# Highlights of homework answers: Detectors

ATHENA Answers to  
DPAP Questions  
(received on 12/17, 2021)

ATHENA Answers to  
DAC Questions  
(received on 12/22, 2021)

**2nd MAPS-Detector to be operated : ALICE ITS upgrade - the ALPIDE Tower 180nm based sensors**

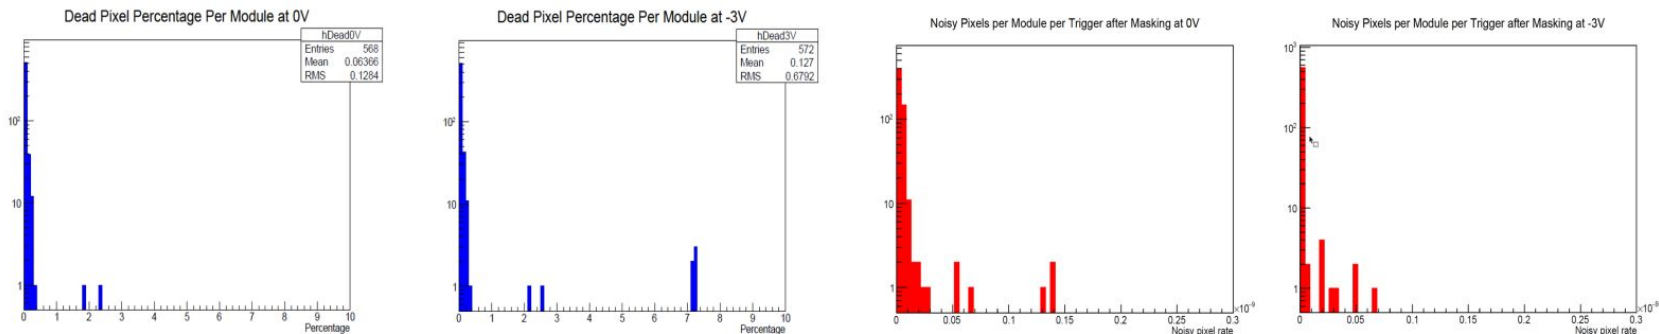
**TR2** Based on knowledge and operational experience from currently installed/operating silicon-based systems, estimate the **number (or fraction) of dead channels** to be expected in your proposed tracker (as function of time, if possible). Estimate the **impact** of this typical number of dead pixels/sectors **on physics results**. What fraction of the MAPS units will be active (versus passive balconies)?

- The installed ITS upgrade detector has a **very high fraction of live pixels**
- **Extensive beam running over next years** (any issues expected to be addressed in the ITS-3 sensor)
- Based on extensive testing of ALPIDE: **sensors should maintain their full existing live over 10 years** of running at the LHC
- For the EIC use, **we expect damage from radiation to be negligible** (the dose rates are at least a factor of 100 below)

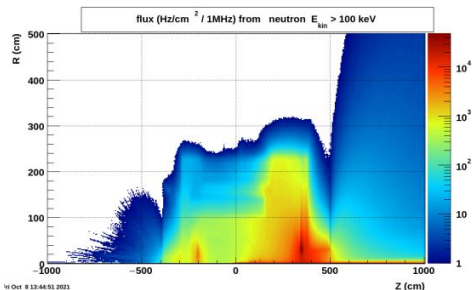
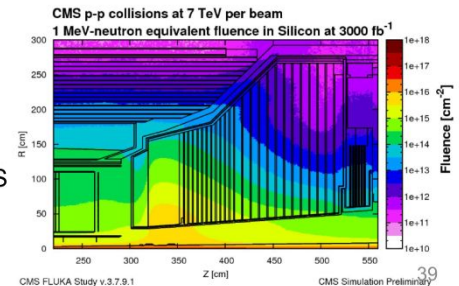
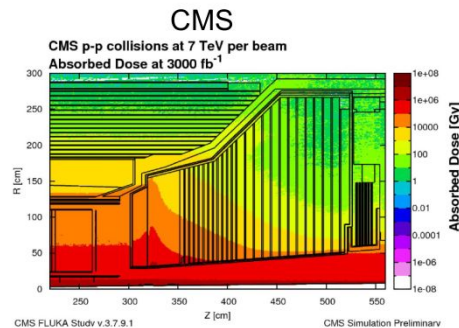
**T-6** How will **radiation damage** of detector components affect physics performance, including forward and backward instrumentation? Please provide a map of the radiation field in the detector.

- **Dose from secondary e+e- particles**
  - <10 kRad / year in ATHENA ...
  - ... compared to dozens of MRad @ CMS

- **Neutron fluence**
  - At most ~10<sup>11</sup> cm<sup>-2</sup> annually in ATHENA ...
  - ... compared to 10<sup>15</sup> cm<sup>-2</sup> and more @ CMS

# Impact of Imaging Layers in Barrel ECAL

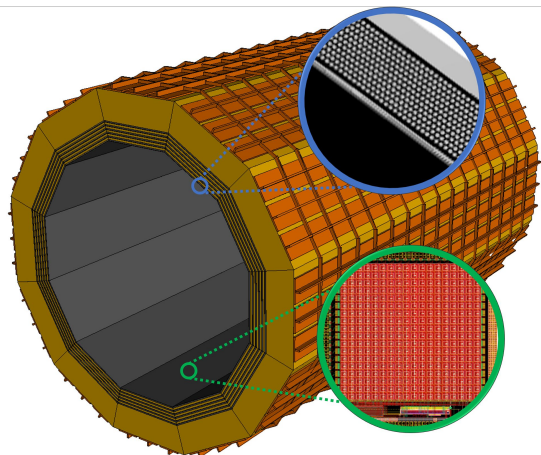
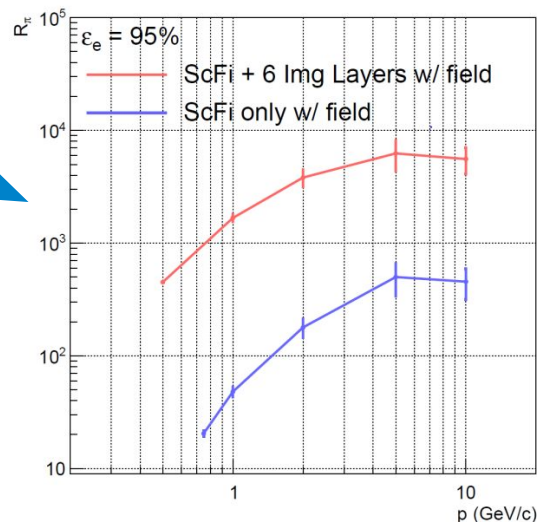
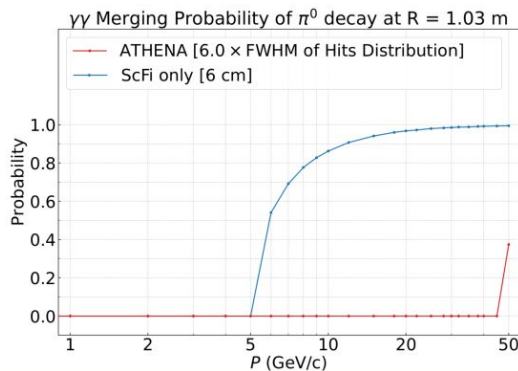
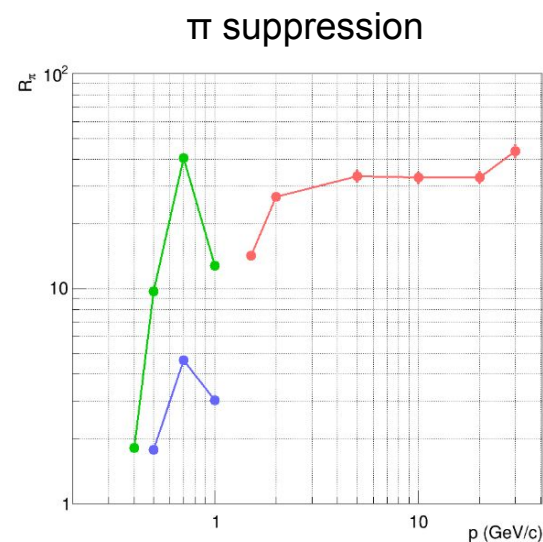
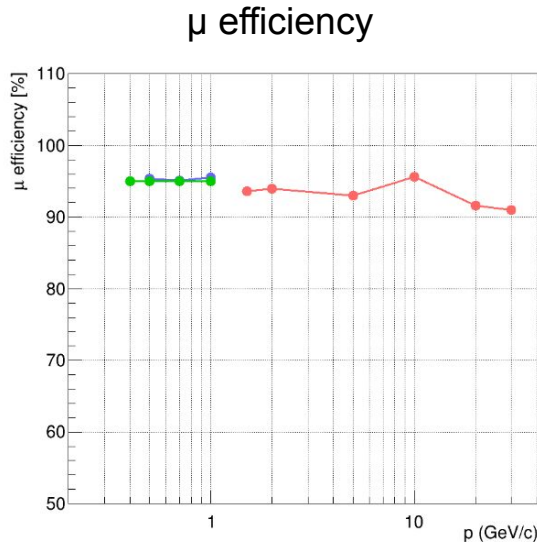
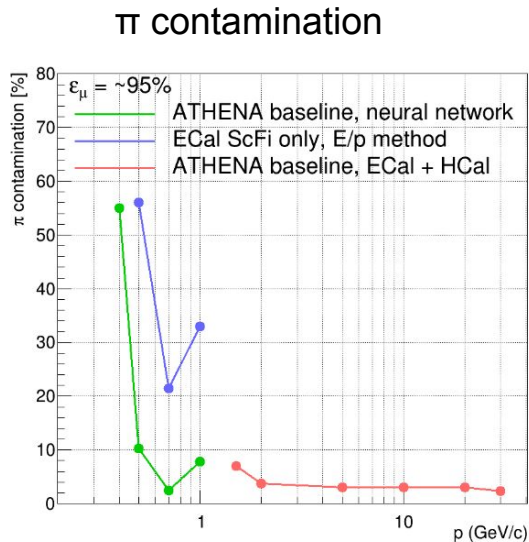
**CA1** The barrel ECAL is an innovative detector and will add some additional integration requirements and risk.

- What are the **physics impacts** of the proposed design relative to a more simple design without the imaging layers?
- Could you describe in more detail the **role of the different groups** in the design, construction, commissioning, electronics, etc for this detector?

Significantly improved **electron/pion separation** with respect to E/p method

**Separation of  $\gamma$ s from  $\pi^0$  decays** at high momenta up to  $\sim 40$  GeV/c.

**Imaging layers provide:**

Allowing PID of **low energy muons** that curl inside the barrel ECal ( $< 1.5$  GeV with 3T MF)

Provides a **space coordinate for DIRC** reconstruction (no need for additional large-radius tracking detector)

# Muons in the Hadron Endcap region

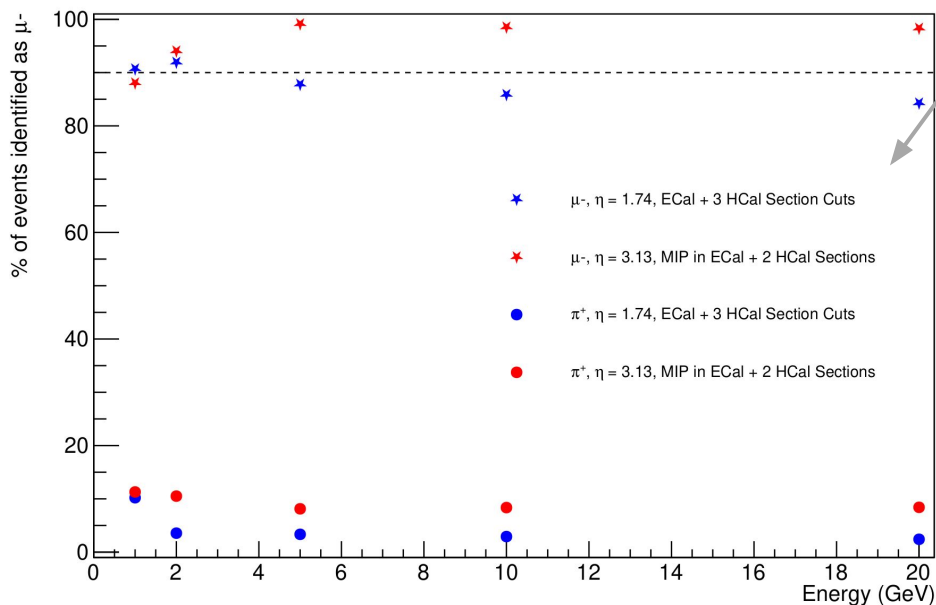
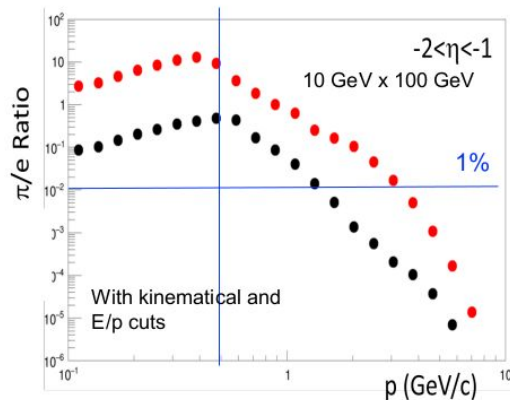
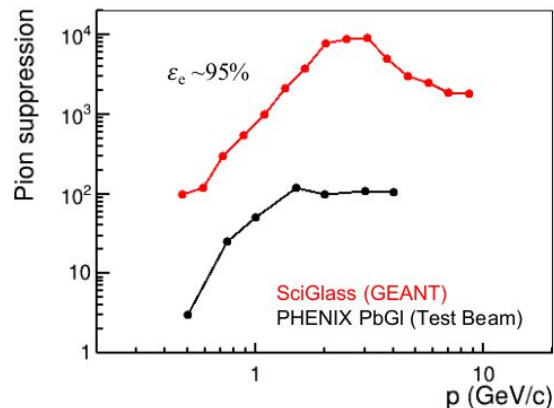
**G-5** Provide estimates of the **pi/mu rejection** factor in different regions of pseudorapidity

- Muon/pion separation in **forward region** determined from **pECal** and **pHCal** responses
  - pEndCap calorimeter has five longitudinal segments: pECal + four sections in pHCal, total  $\sim 7$  interaction lengths

Percent of events identified as muons for generated pion sample (pion contamination, dots) and muon sample (muon efficiency, stars) at  $\eta=1.74$  and  $\eta=3.13$

For  $\sim 90\%$  muon efficiency, only a few % of pions are misidentified as muons

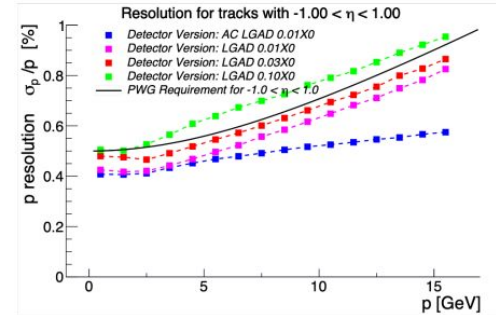
**T-3** What happens to the physics performance if **AC-LGADs have to be replaced by something else** (e.g. LGADs)?

- **bToF:** barrel ToF for low- $p_T$  PID at midrapidity
- **Roman Pots:** far-forward position and timing of scattered proton
- **B0:** far-forward timing of charged particles
- **Off-Momentum Detector:** far-forward position and timing of charged particles

**Short answer:** We are confident that AC-LGAD is the right choice for bToF and would be willing to wait, if needed, for a delayed installation after start-of-operation. Well established alternative technologies can be used in the three far-forward detectors w/o compromising physics performance.

- **Roman Pots and OMD:** If AC-LGADs are unavailable: existing MAPS with a suitable timing layer (e.g. DC-LGAD) would satisfy all the requirements
- **B0:** Alternative timing layer using DC-LGADs (strips) using two layers for x & y orientation

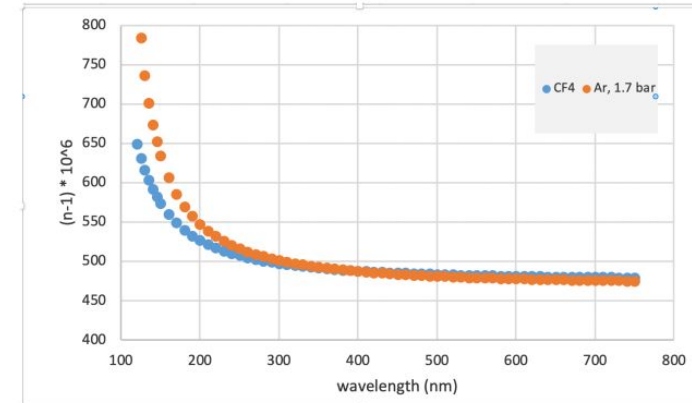
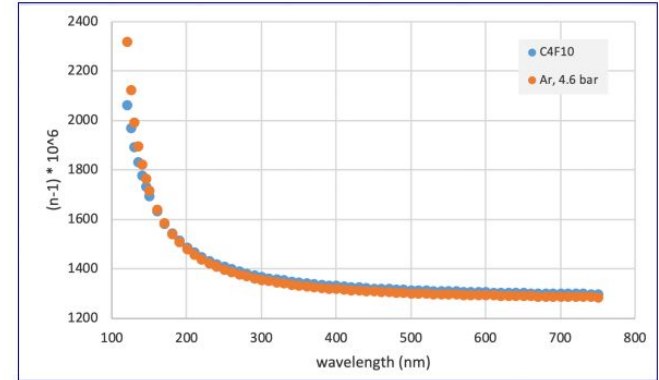
- T-4** (i) What happens to the physics performance **if C<sub>2</sub>F<sub>6</sub> and C<sub>4</sub>F<sub>10</sub> cannot be used?**  
(ii) Have you considered using alternative gases for the initial design rather than as a later modification?

- **Fluorocarbons** are selected as radiator gasses in gaseous RICHes because of their :
  - ✓ **High density** at room conditions → high Cherenkov photon yield
  - ✓ **Small chromaticity** → good Cherenkov angle resolution
- These requirements **must** be preserved to ensure ATHENA PID performance. They can be obtained pressurizing Ar at ~ 3 bar.
  - ✓ Contrary to fluorocarbons, Ar does not have green-house issues. It is cheaper, easier to procure, does not require complex gas recycling systems.

- **Yes: we are considering pressurized Ar for the initial design**
  - ✓ The challenge is the mechanical design of the vessel, that should guarantee safety operation with limited amount of material
  - ✓ Preliminary studies of this design have started

**Example:**  
Impact on  $\lambda$   
reconstruction  
efficiency

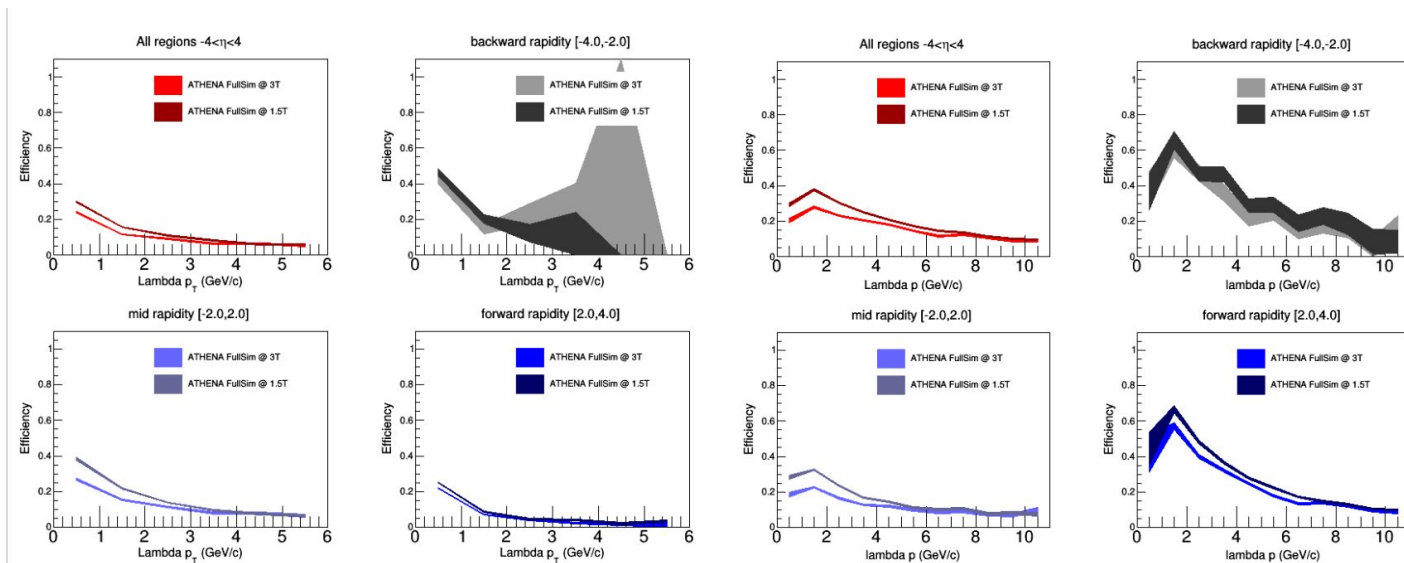
**T-2** Can the **physics performance** be **optimized by adjusting the field strength** of the spectrometer magnet to the beam energies of different runs?

- **The field can be reduced:** no technical limitation exists to operate the magnet at a lower field at any beam energy, neither from the solenoid, detector nor the accelerator side. However, we consider the **full 3T field the optimal choice for the body of NAS measurements.**
- The main performance impact of reducing the B-field is an **increased acceptance at low  $p/p_T$** , nevertheless at the expense of **losing  $p/p_T$  resolution** in combination with a **worse signal to background ratio** (e.g. D0).
- The ultimate decision if low B-field runs are needed at all at different  $\sqrt{s}$  will be best based on operational experience.

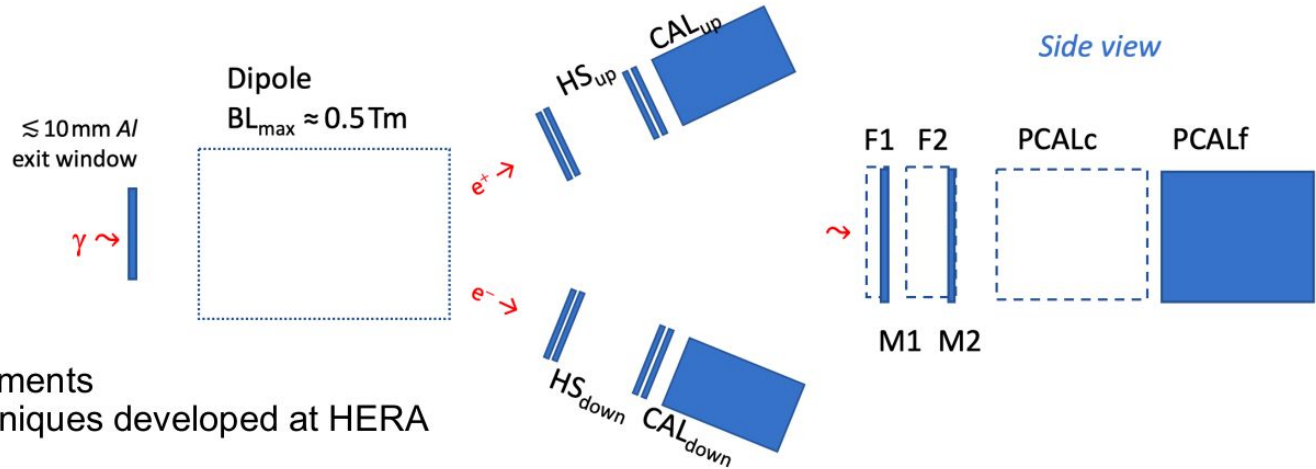
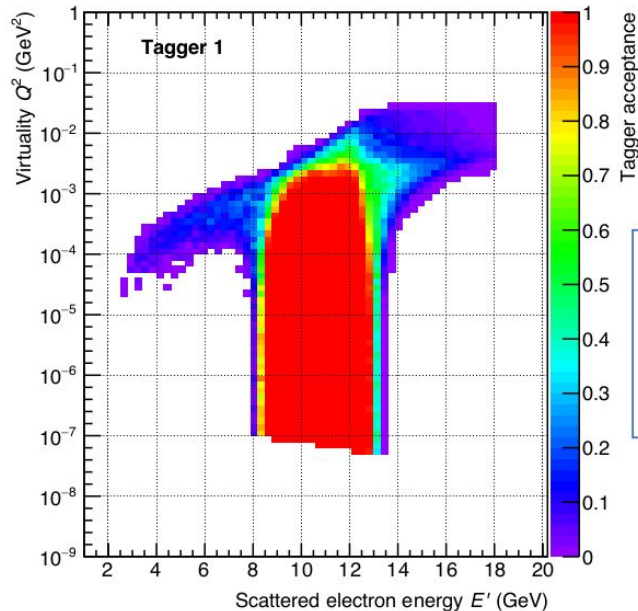
**G-6** Provide some detail on how you estimate the accuracy of the **luminosity measurement**

- ATHENA luminosity measurements are based on **extending** techniques developed at HERA
- **Three complementary methods** will be used for luminosity determination: (a) bremsstrahlung photon counting using (movable) PCALc; (b) counting of photon conversions in exit window using “luminosity spectrometer”; (c) photon energy flow measurement using PCALf (and movable SR filters F1/2 and monitors M1/2). These 3 methods, affected by very different systematic uncertainties, will be cross-calibrated to each other.
- This will ensure **1% luminosity precision** for all electron beam energies (from 5 to 18 GeV) as well as hadron beam species (from protons to gold nuclei), and for low and high luminosity running at EIC

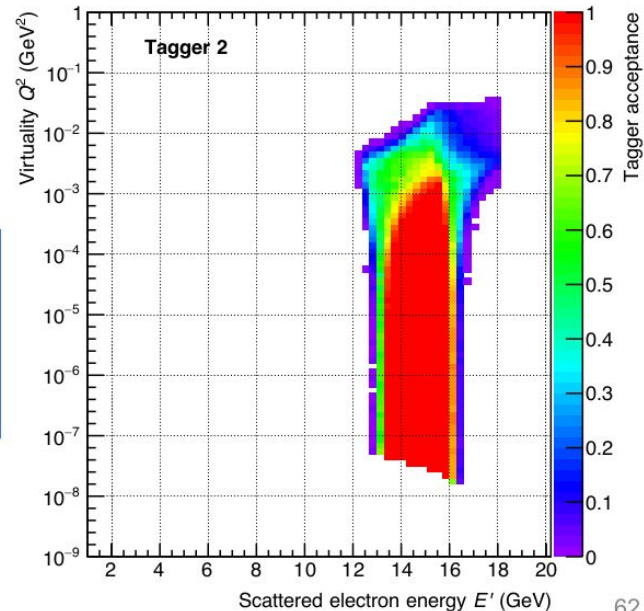
**G-7** Provide some details about the acceptance and resolution in  $Q^2$  and energy for **electrons scattered at very low angles**

- The acceptance of low- $Q^2$  taggers in ATHENA is limited by the apertures of the upstream electron beamline elements and by the presence of the dipole magnet B2eR, in front of the taggers. To maximize the electron acceptance and avoid unnecessary complications we propose to install **two electron detectors**, *Tagger 1* at 20 m from IP6 and *Tagger 2* at 37 m, with complementary acceptances, as shown for 18 GeV electrons:

High acceptance, close to 100%,  
is expected for the region:

$$0.9 > y > 0.5 \text{ and } Q^2 < 10^{-3} \text{ GeV}^2,$$
